ITB: 2219225

Addendum:

Dept of Youth Services
Entrance
Areas to be Widened 6'

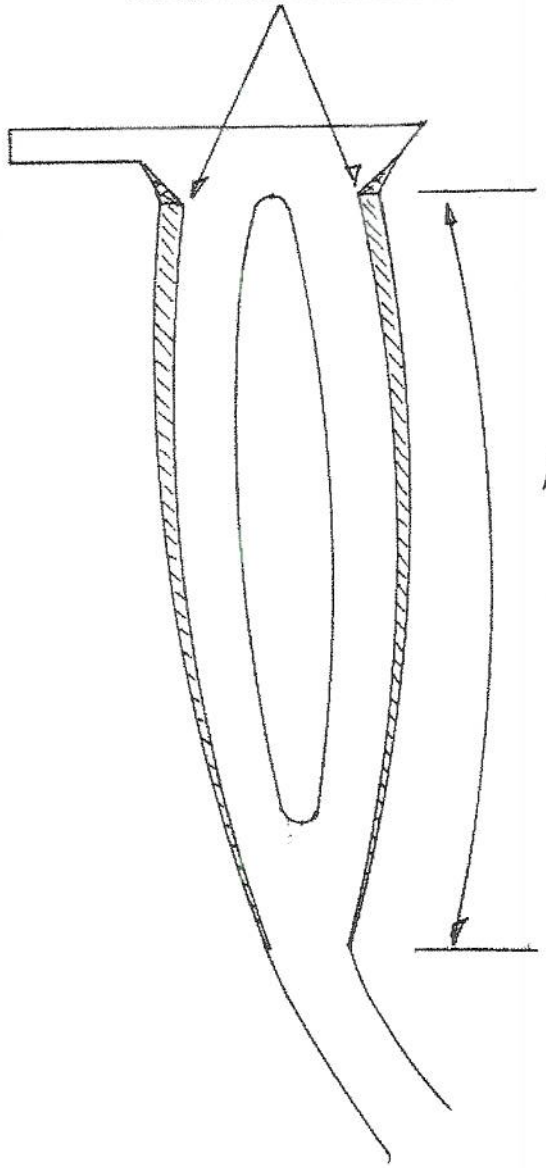
1. Change length on widen both sides of entrance to approximately 350'
   See Drawing 1

Approximately
350'

This would add
Approximately 52 SY
or 468 sf

Truck Turnaround Area

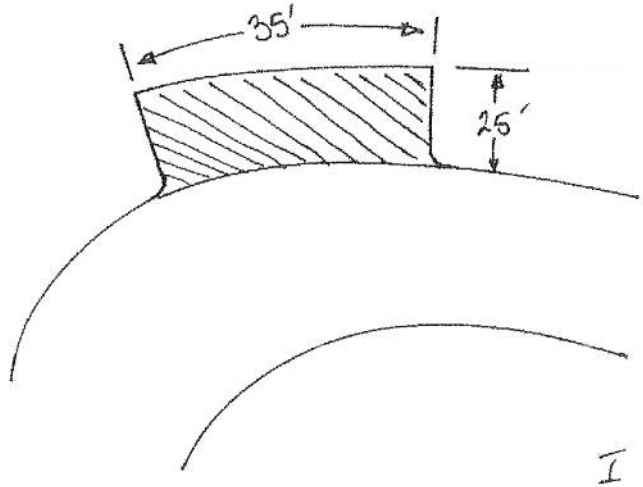
2. Add Truck Turnaround Area, 25'x35', Approximately 875 Sq Ft
   See Drawing 2

This would add Approximately 98 SY or 875 sf

I would recommend the same buildup in this area as that to be used on the widening in the entrance.

Dumpster Approach Area

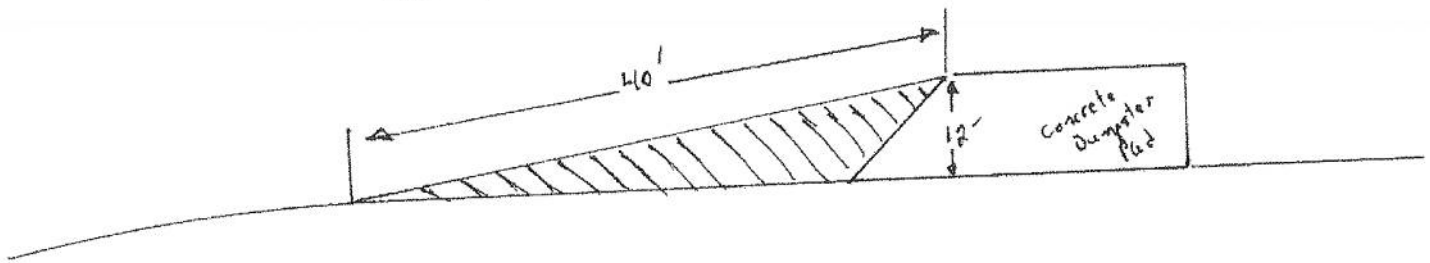
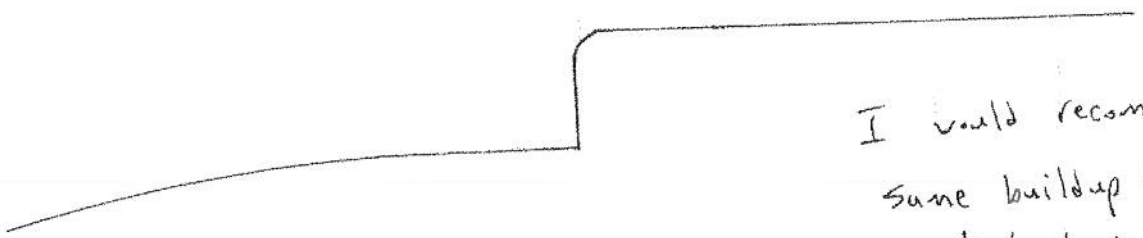
3. Add Dumpster Approach Area, Approximately 220 Sq Ft
   See Drawing 3

This would add
Approximately 27 SY
or 240 sf

I would recommend the same buildup in this area as that to be used on the widening in the entrance.
